ADDENDUM NO. 2

**PROJECT NO. 2036N1007Z TMUA-W 20-08 Non-Arterial Street Rehabilitation Zone 1007 Admiral Pl. From Quincy Ave. To Utica Ave.**

**ADDENDUM NO. 2**  
**TO**  
**PROJECT NO. 2036N1007Z TMUA-W 20-08**  
**Non-Arterial Street Rehabilitation Maintenance Zone 1007**  
**Admiral Pl. From Quincy Ave. To Utica Ave.**

TYPICAL SECTIONS (1 OF 2)  
 MAINTENANCE ZONE 1007  
 PROJECT NO. 2036N1007Z  
 CITY OF TULSA, OKLAHOMA  
 PUBLIC WORKS

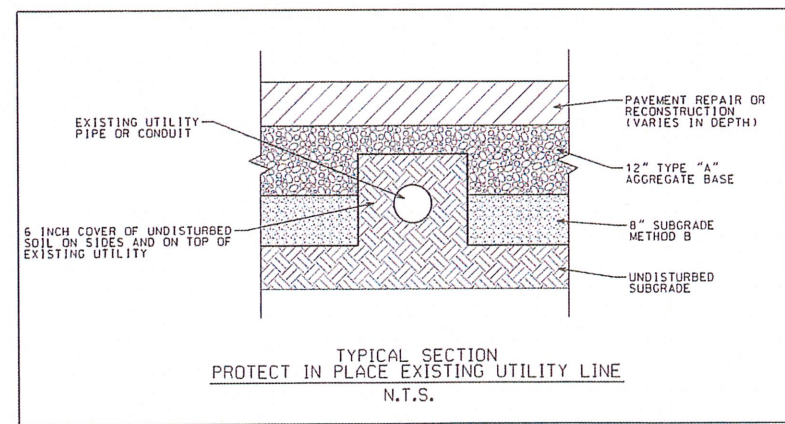
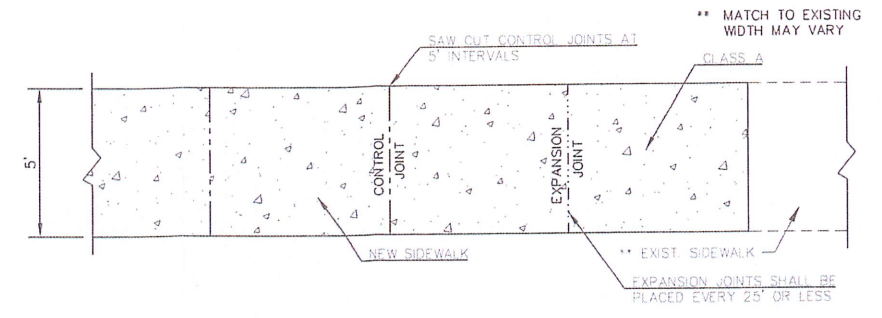
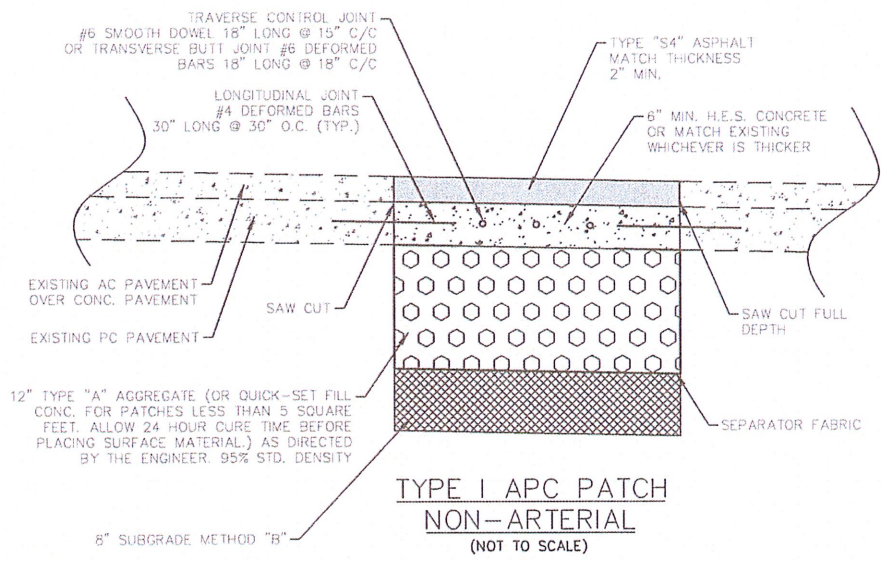
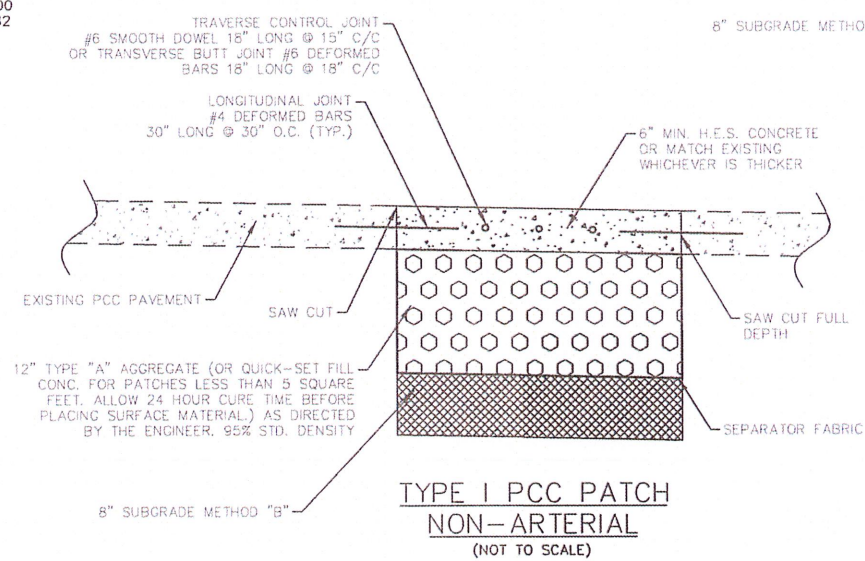
3. Backfill note 1 on sheet 7 states that 2 FT of solid slab sodding shall be included in other items of work. Is this note correct, if so, what is the intended use of the solid slab sodding bid item?

5. Sheet 7 – Revised Note  
6. Sheet 8 – Revised Note

① BACKFILL NOTE:  
 TO BE BACKFILLED 1' IN BACK OF CURB WITH AND COMPACTED AS PART OF THE FINISHING OPERATIONS. -60% OF 2" OF SOLID SLAB SOD TO BE INCLUDED IN OTHER ITEMS OF WORK-

The backfill note is incorrect. The 1ft of sod included in the plans are intended go behind the curb. A revised sheet 7 is included as part of this addendum.

TYPICAL SECTIONS (2 OF 2)	
MAINTENANCE ZONE 1007 PROJECT NO. 2036N1007Z	
CITY OF TULSA, OKLAHOMA PUBLIC WORKS	
PLANS PREPARED BY: CITY OF TULSA

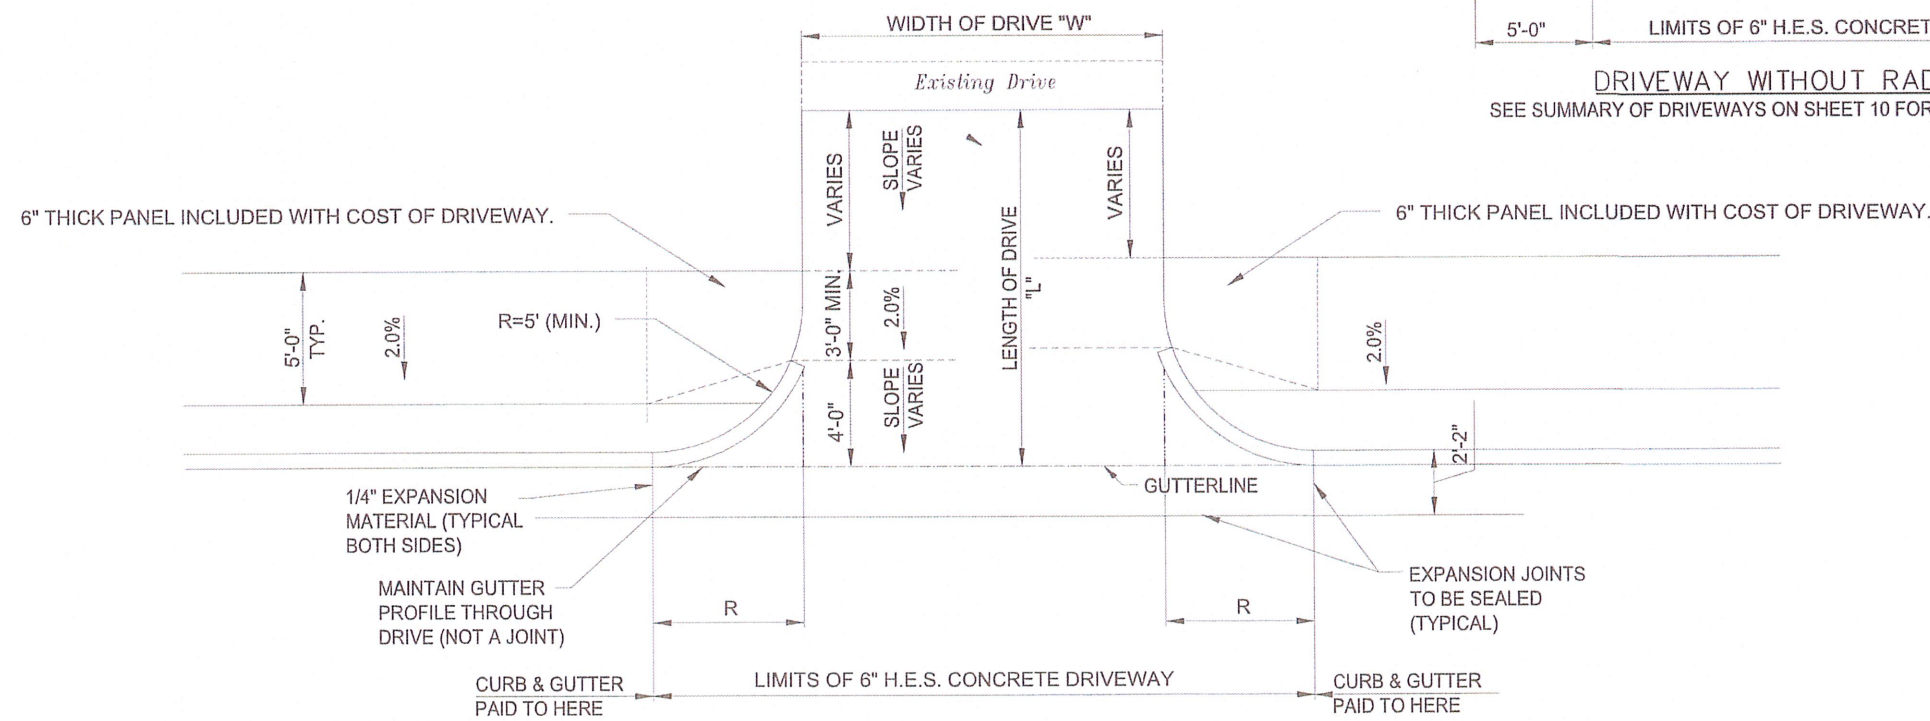
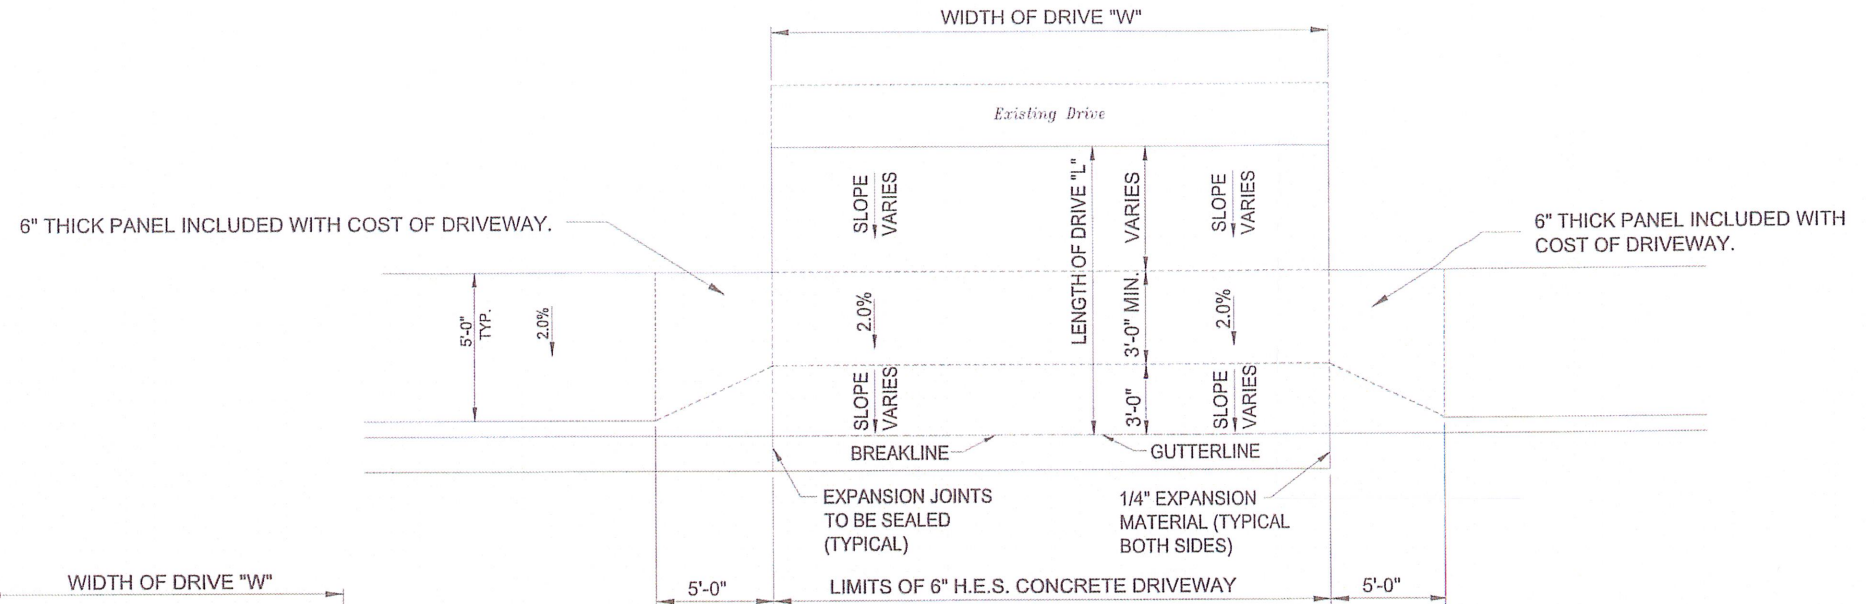
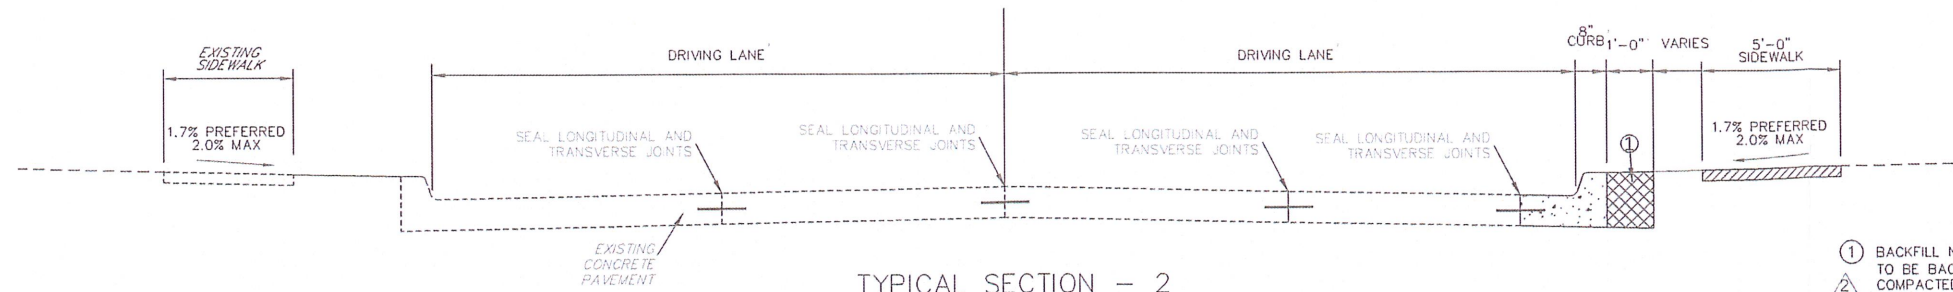
4. Can you please clarify if the following note for driveways on sheet 8 is correct? "6" Thick Panel Included with Cost of Driveway" This panel adjacent to drives has always paid as sidewalk and just been understood to be 6" thick. City of Tulsa's quantities lead me to believe that it is to be bid as the traditional way of it being a thicker panel and paid as sidewalk, however, this note contradicts that.

- ① BACKFILL NOTE: TO BE BACKFILLED 1' IN BACK OF CURB WITH AND TO BE COMPACTED AS PART OF THE FINISHING OPERATIONS. COST OF 2" OF SOLID SLAB SOG TO BE INCLUDED IN OTHER ITEMS OF WORK.
- ②

Driveway placement is paid in bid item 14 by the square yard. Sidewalk placement is paid in bid item 13 by the square yard. The cost of the additional thickness of the sidewalk adjacent to driveways is incidental to the driveway placement.
